SUFFOLK COUNTY PLANNING COMMISSION

Notice of Meeting

June 1, 2016 at 2:00 p.m.

STAFF REPORT

Z-2: Canoe Place Inn
 SCPD: SH-14-03
 SCTM No: 0900-207.00-05.00-003.004 et al.

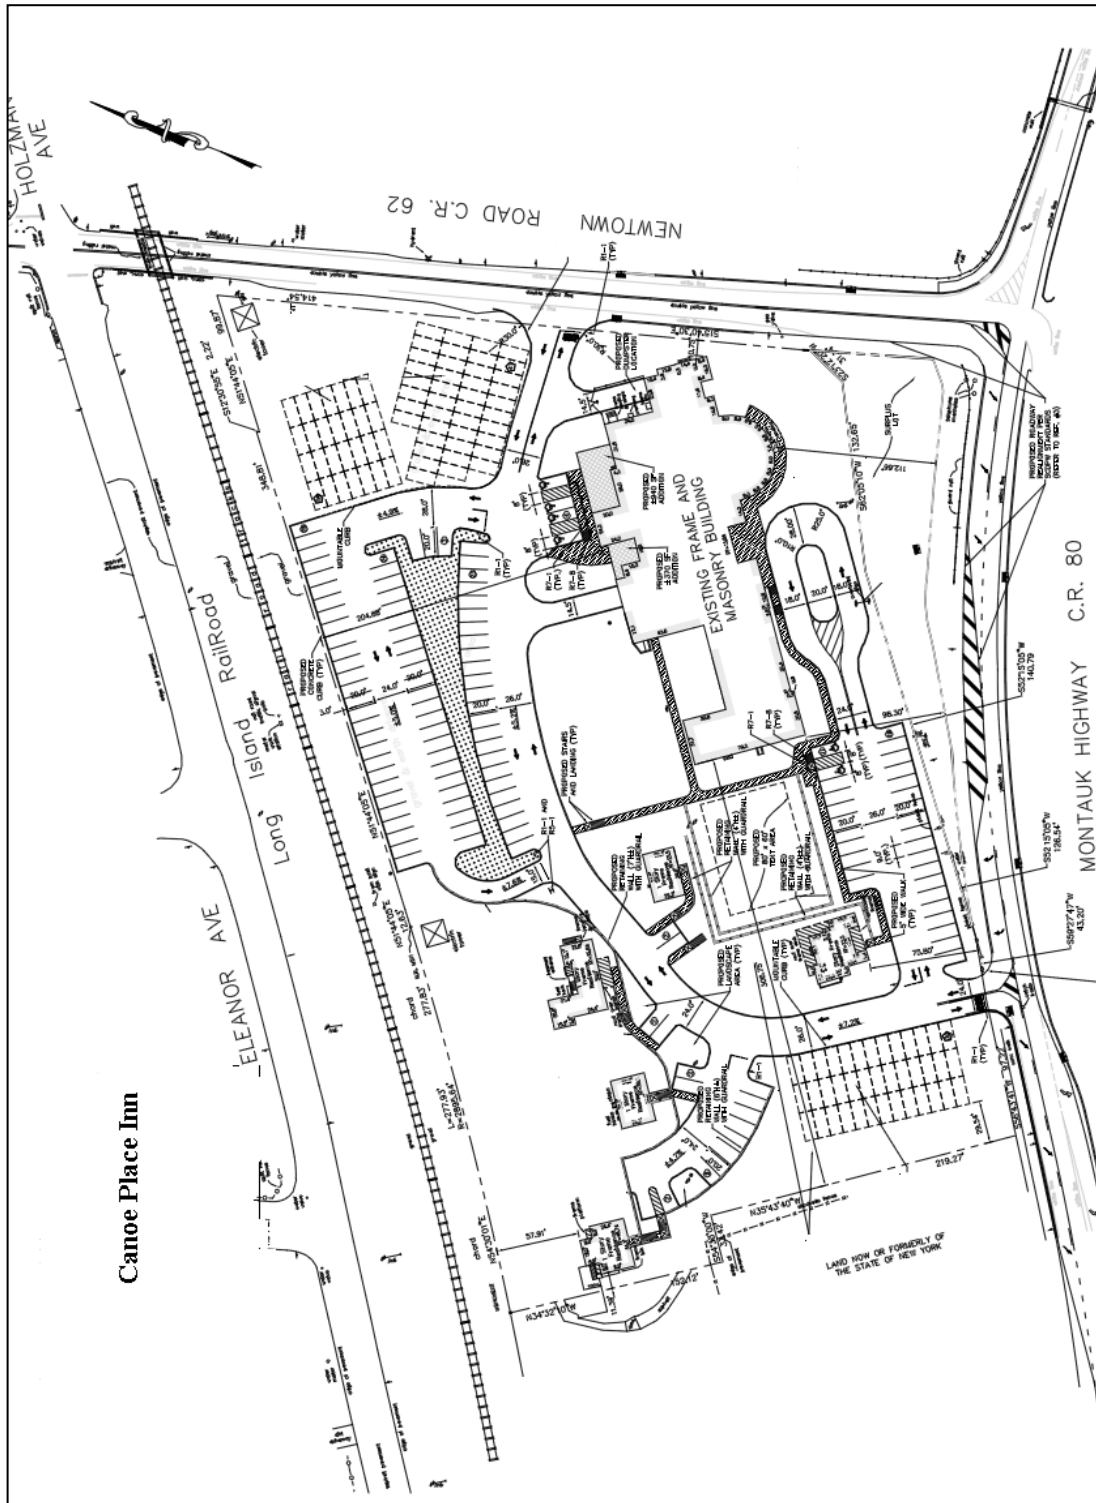
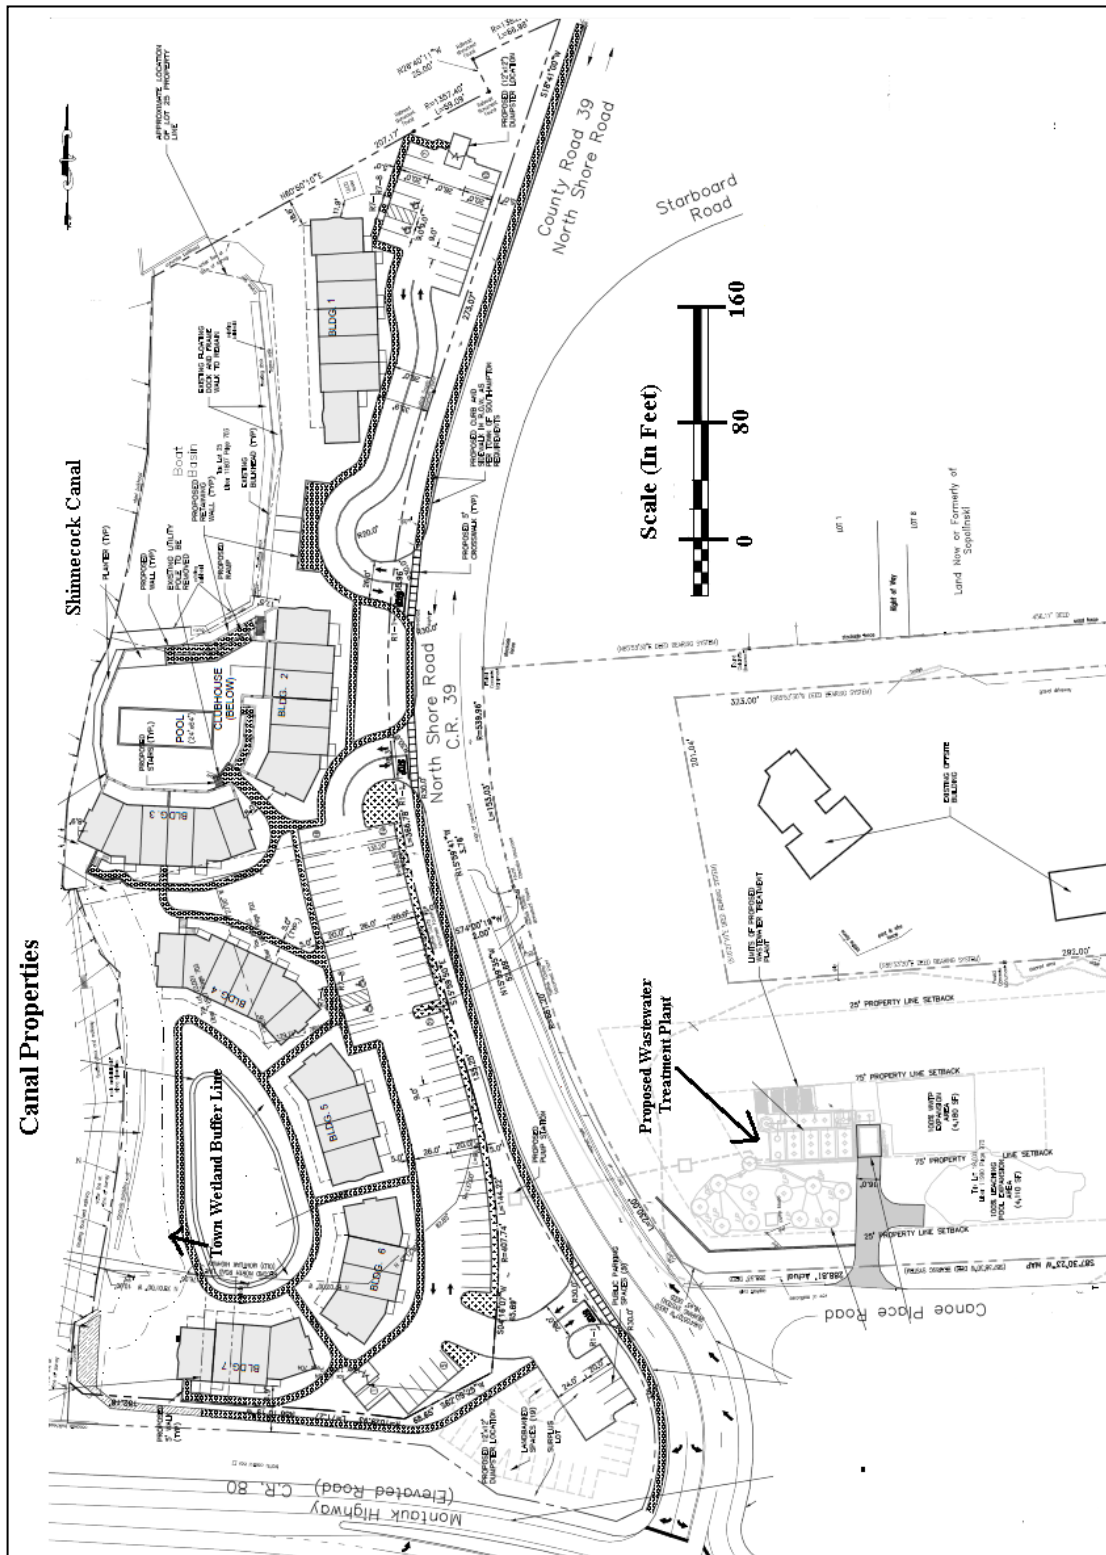
Submission materials to the Commission indicate that NYS DEC requirements for storm water runoff treatment will be met. The petitioners should also be encouraged to review the Suffolk County Planning Commission publication on *Managing Stormwater-Natural Vegetation and Green Methodologies* and incorporate into the proposal, where practical, design elements contained therein. It is noted that a drainage reserve area, located at the southern end of the Canal Property, is a large depression set in the grade that will capture and recharge a portion of the storm water runoff into the surrounding soil. Low points situated throughout the site are intended to collect storm water runoff and direct it into the recharge system.

It should be noted that the proposed development is not located in a floodplain. However, the shoreline of the Canal Property is not entirely bulk-headed along the shore of the Shinnecock Canal. The most landward limit of tidal wetlands associated with the shoreline of the Shinnecock canal should be flagged in the field by a qualified expert, verified by the appropriate agencies, and noted as such shown on all surveys, sketches, map, plans, etc. and all regulatory setbacks for disturbance and construction taken from said most landward limit.

No mention of the consideration of energy efficiency is provided in the referral material to the Suffolk County Planning Commission. The petitioners should be encouraged to review the Suffolk County Planning Commission Guidebook particularly with respect to energy efficiency and incorporate where practical, elements contained therein applicable for residential and clubhouse components of the proposal.

There is no mention in the referral materials to the Suffolk County Planning Commission on the petitions compliance with the NYS Long Island Workforce Housing Act. It is noted that the residential component is a voluntary reduction in allowable yield however, it is not apparent that as part of a mixed use development, a lesser percentage than the maximum allowable floor area ratio is being proposed for the entire CPIMPDD and thus would exempt the project from the Act. This should be re-emphasized and further clarified or accommodation to the Housing Act should be made by the project sponsor.

Little discussion is made in the petition to the Town and referred to the Commission on public safety and universal design. The applicant should review the Planning Commission guidelines particularly related to public safety and universal design and incorporate into the proposal, where practical, design elements contained therein.

Approval of the Canoe Place Inn Maritime Planned Development District with the following comments:

1. The petitioner should continue dialogue with the Suffolk County Department of Health Services, Suffolk County Department of Public Works and the Suffolk County Sewer Agency with regard to the permitting of the Nitrex wastewater treatment systems proposed.

3. It is noted that a drainage reserve area, located at the southern end of the Canal Property, is a large depression set in the grade that will capture and recharge a portion of the storm water runoff into the surrounding soil. Low points situated throughout the site are intended to collect storm water runoff and direct it into the recharge system. The petitioners should be encouraged to review the Suffolk County Planning Commission publication on *Managing Stormwater-Natural Vegetation and Green Methodologies* and incorporate into the proposal, where practical, additional design elements contained therein.

4. The most landward limit of tidal wetlands associated with the shoreline of the Shinnecock canal should be flagged in the field by a qualified expert, verified by the appropriate agencies, and noted as such, shown on all surveys, sketches, map, plans, etc. and all regulatory setbacks for disturbance and construction taken from said most landward limit.

5. There is no mention in the referral materials to the Suffolk County Planning Commission on the petitions compliance with the NYS Long Island Workforce Housing Act. It is noted that the residential component is a voluntary reduction in allowable yield however, it is not apparent that as part of a mixed use development, a lesser percentage than the maximum allowable floor area ratio is being proposed for the entire CPIMPDD and thus would exempt the project from the Act. This should be re-emphasized and further clarified or accommodation to the Housing Act should be made by the project sponsor.

6. No mention of the consideration of energy efficiency is provided in the referral material to the Suffolk County Planning Commission. The petitioners should be encouraged to review the Suffolk County Planning Commission Guidebook particularly with respect to energy efficiency and incorporate where practical, elements contained therein applicable for the commercial, residential and clubhouse components of the proposal.

7. The petitioners should review the Planning Commission guidelines particularly related to public safety and incorporate into the proposal, where practical, design elements contained therein.
8. The petitioners should review the Planning Commission guidelines particularly related to universal design and incorporate into the proposal, where practical, design elements contained therein.

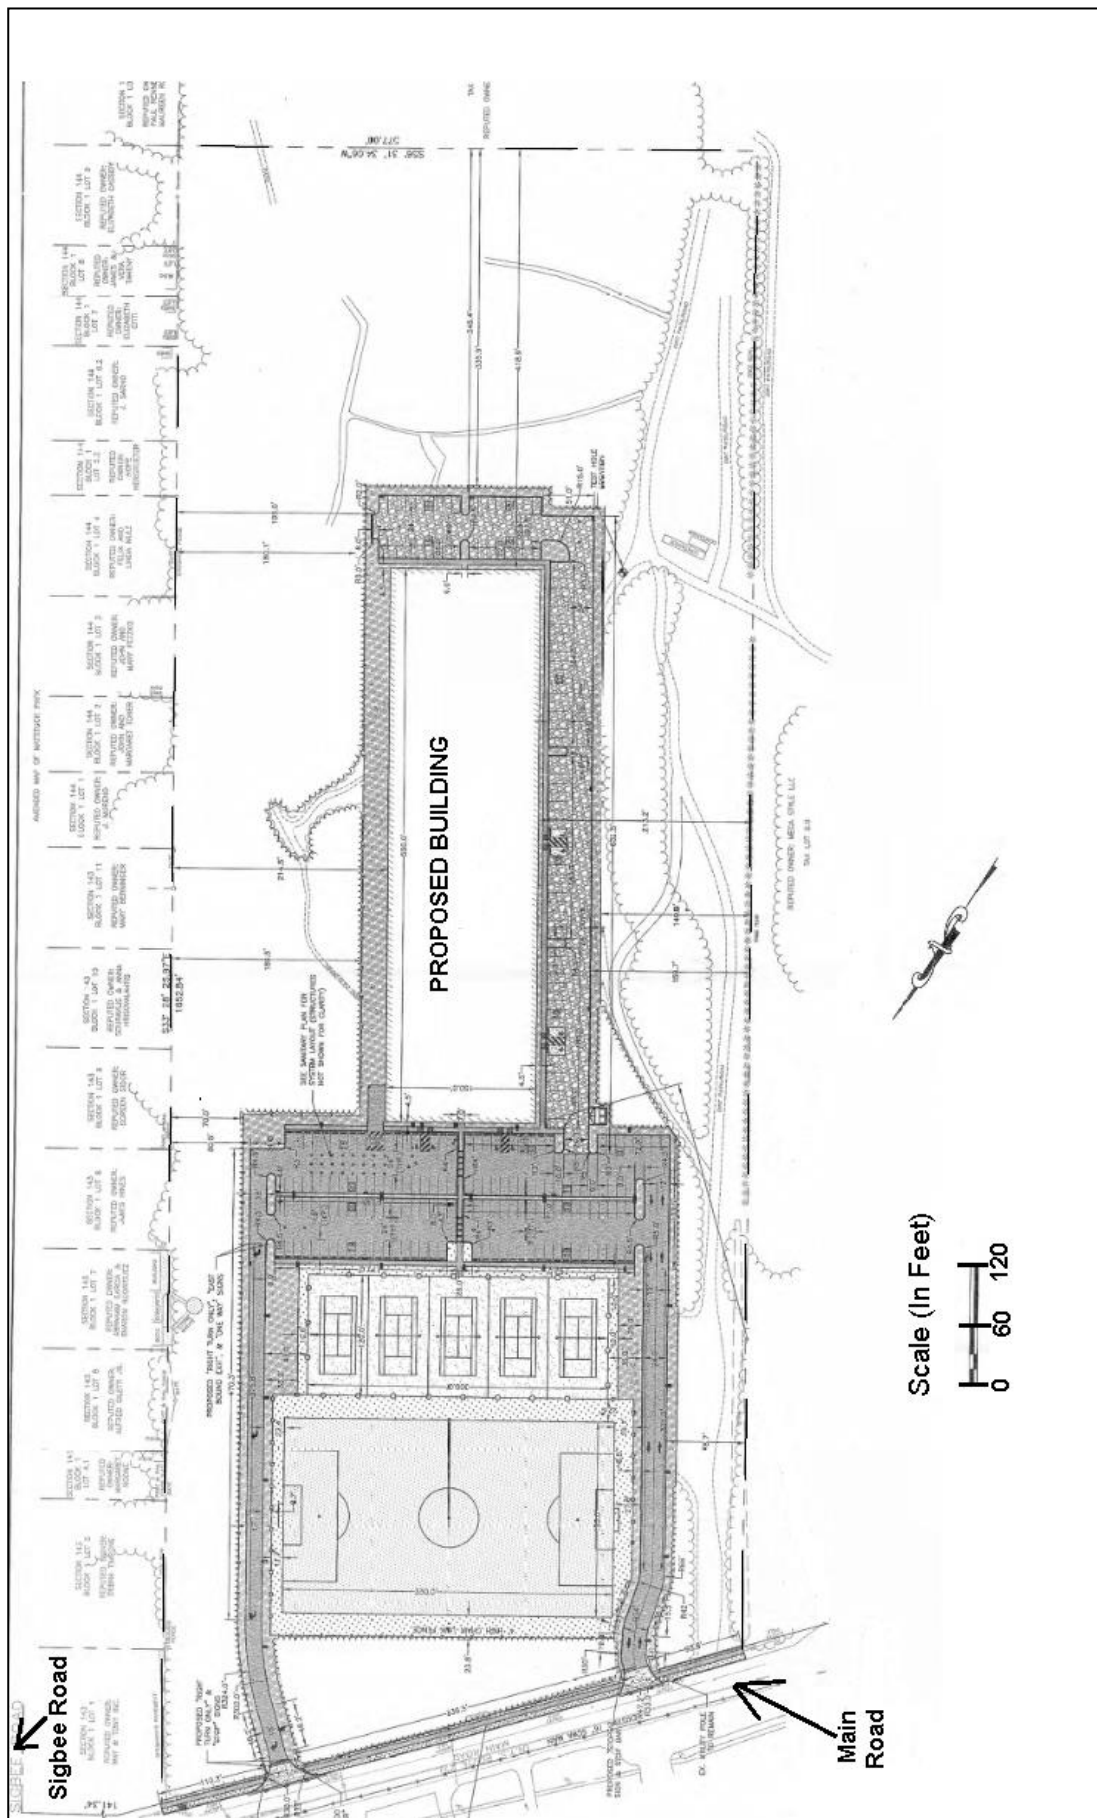
Storm water runoff from the proposed project will be retained on-site and recharged via a drainage system designed to conform to all applicable Town requirements. This system will include a subsurface drainage system comprised of precast concrete catch basins, leaching pools and permeable areas (crushed stone). It is the belief of staff that opportunities exist on site to incorporate additional best management practices to the treatment of storm water runoff. The petitioners should be encouraged to review the Suffolk County Planning Commission publication Managing Stormwater-Natural Vegetation and Green Methodologies and incorporate into the proposal, where practical, design elements contained therein.

There was not information in the referral materials indicating that the project will incorporate energy efficiency into the site design. The petitioners should be encouraged to review the Suffolk County Planning Commission Guidebook particularly with respect to energy efficiency and incorporate where practical, elements contained therein for the residential and community center components of the development.

The applicant has put forth in submitted materials that the Sports East Recreation Club will not result in a substantial increase to traffic above present levels or generate a substantial new demand for transportation facilities or services. The applicant indicates that a traffic impact study will be prepared to address any increase in traffic or congestion. The study once completed is to be submitted to the NYS DOT for review.

Suffolk County Bus Transit route SC-92 runs along Main Road (NYS Route 25). The applicant should contact Suffolk County Transit to coordinate bus service to the proposed development.

Little discussion is made in the petition to the Town and referred to the Commission on public safety and universal design. The applicant should review the Planning Commission guidelines particularly related to public safety and universal design and incorporate into the proposal, where practical, design elements contained therein.

Approval of the site plan for The Sports East Fitness Club with the following comments:

1. Advanced wastewater treatment including the possibility of innovative/alternative nitrogen reducing systems are appropriate for this proposed development and the petitioner should be directed to continue dialogue with the Suffolk County Department of Health Services regarding the use of innovative alternative wastewater treatment for the proposed development.
2. The applicant should be encouraged to review the Suffolk County Planning Commission publication on Managing Stormwater-Natural Vegetation and Green Methodologies and incorporate into the proposal, where practical, design elements contained therein.
3. The applicant should be encouraged to review the Suffolk County Planning Commission Guidebook particularly with respect to energy efficiency and incorporate where practical, applicable elements contained therein.

4. A traffic impact study should be prepared to address any increase in traffic or congestion to NYS Rte. 25. The study once completed should be submitted to the NYS DOT for review.
5. Suffolk County Bus Transit route SC-92 runs along Main Road (NYS Route 25). The applicant should contact Suffolk County Transit to coordinate bus service to the proposed development.
6. The applicant should review the Planning Commission guidelines particularly related to public safety and incorporate into the proposal, where practical, design elements contained therein.
7. The applicant should review the Planning Commission guidelines particularly related to universal design and incorporate into the proposal, where practical, design elements contained therein.
